Project	IEEE 802.16 Broadband Wireless Access Working Group < http://ieee802.org/16 >	
Title	MR_Traffic-REP message	
Date Submitted	2007-11-08	
Source(s)	Kanchei (Ken) Loa, Yi-Hsueh Tsai, Yung-Ting Lee, Hua-Chiang Yin, Shiann-Tsong Sheu, Youn-Tai Lee	Voice: +886-2-27399616 Fax: +886-2-23782328 loa@iii.org.tw
	Institute for Information Industry 8F, No. 218, Sec. 2, Dunhua S. Rd., Taipei City 106, Taiwan	
	[add other co-authors here]	
Re:	IEEE 802.16j-07/043: "IEEE 802.16 Working Group Working Group Letter Ballot #28"	
Abstract	This contribution proposes MS ranging and automatic adjustments in transparent and non-transparent	
Purpose	Text proposal for 802.16j Draft Document.	
Notice	<i>This document does not represent the agreed views of the IEEE 802.16 Working Group or any of its subgroups. It represents only the views of the participants listed in the "Source(s)" field above. It is offered as a basis for discussion. It is not binding on the contributor(s), who reserve(s) the right to add, amend or withdraw material contained herein.</i>

MR_Traffic-REP message

Specification Changes

Figure 118b—SS upstream transmission adjustment at a transparent RS performing uplink relay only

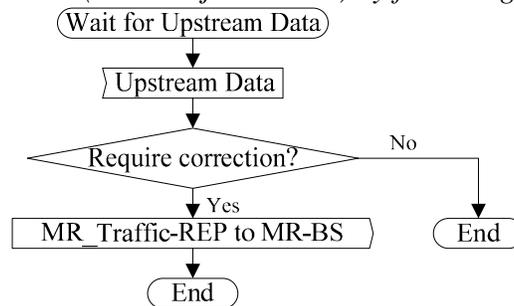
[Replace Figure 118b in comment #0565 (C802.16j-07/459r6) by following figure as indicated:]
